Access Compliance Report

Public Rights-of-Way

(Curb Ramps)

Intersection ID: 51072	Main Street: KEMPSFORD_DR	Cross Street: GRICKLADE_DR	Location: SE
ADA ID: 3665692630CA	Ramp Type: PerpDiag	Initial Pass/Fail: Fail	Overall Compliance: No
			Severity Score: 33.75

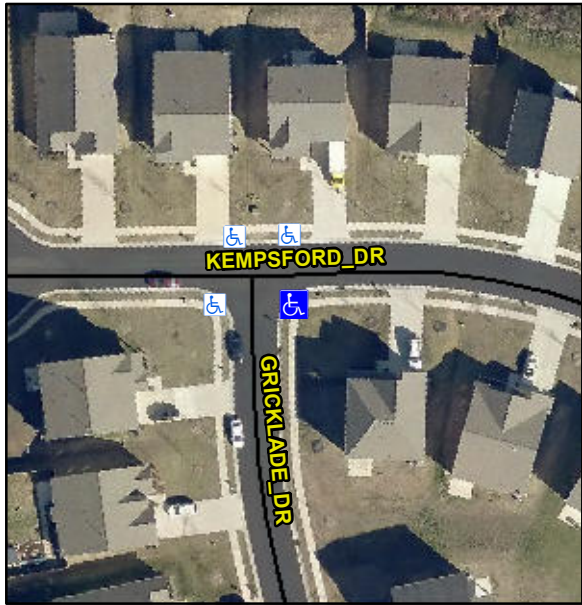
Codes/Mitigation Info/Possible Solution			Field Measurements/Component Compliance					
	Possible Solutions:		Compliance	Description	Data	Compliance	Description	Data
	Remove & Replace Curb Ramp With Two New Directional Ramps or Equivalent.		N/A	Ramp Length (in)	47.0	No	Ramp Slope (%)	12.6
			No	Ramp Width (in)	47.0	Yes	Ramp XSlope (%)	0.8
			N/A	Flare Type LT	N/A	N/A	Flare Type RT	N/A
			N/A	Flare Slope LT (%)	N/A	N/A	Flare Slope RT (%)	N/A
			N/A	Flare Traversable LT?	N/A	N/A	Flare Traversable RT?	N/A
			N/A	Landing Length (in)	N/A	N/A	DWS Provided?	N/A
			N/A	Landing Width (in)	N/A	N/A	DWS Contrast?	N/A
			N/A	Landing Slope (%)	N/A	N/A	DWS Length (in)	N/A
			N/A	Landing X Slope (%)	N/A	N/A	DWS Full Width?	N/A
Surveyor Notes:	N/A		N/A	Landing Curb? (Y/N)	N/A	N/A	DWS Offset (in)	N/A
			N/A	Shared Landing?	N/A			
	PROW/ADA:		N/A	Gutter Ponding?	N/A	N/A	Gutter Slope (%)	N/A
	Not Found, R304.5.1, R304.2.2		N/A	Gutter Lip Ht (in)	0.75	N/A	Gutter X Slope (%)	N/A

N/A	Painted X Walk1?	No	N/A	Painted X Walk2?	No
				X Walk 1 Direction	To N		X Walk 2 Direction	To W
			N/A	X Walk 1 Width (in)	N/A	N/A	X Walk 2 Width (in)	N/A
				X Walk 1 Slope (%)	0.4		X Walk 2 Slope (%)	0.3
				X Walk 1 X Slope (%)	1.6		X Walk 2 X Slope (%)	1.9
			N/A	Ramp inside XWalk1?	N/A	N/A	Ramp inside XWalk2?	N/A
			Road Slope (%)	3.1	N/A	Clear Space?	N/A	
			Road X Slope (%)	0.4	N/A	Clear Space to XWalk (in)	N/A	
		N/A	Any Obstructions?	N/A	N/A	Storm Grate/Utility Hazard?	N/A	
			Obstruction Type			Storm Grate/Utility Type		
					N/A		N/A	
					Yes	Surface Condition? (G/P)	Good	
Total Cost:		\$	3200.00					
Street 1 Name		KEMPSFORD DR						
Stop Condition-Street 2		None						
Street 2 Name		GRICKLADE DR						
Stop Condition-Street 1		StopSign
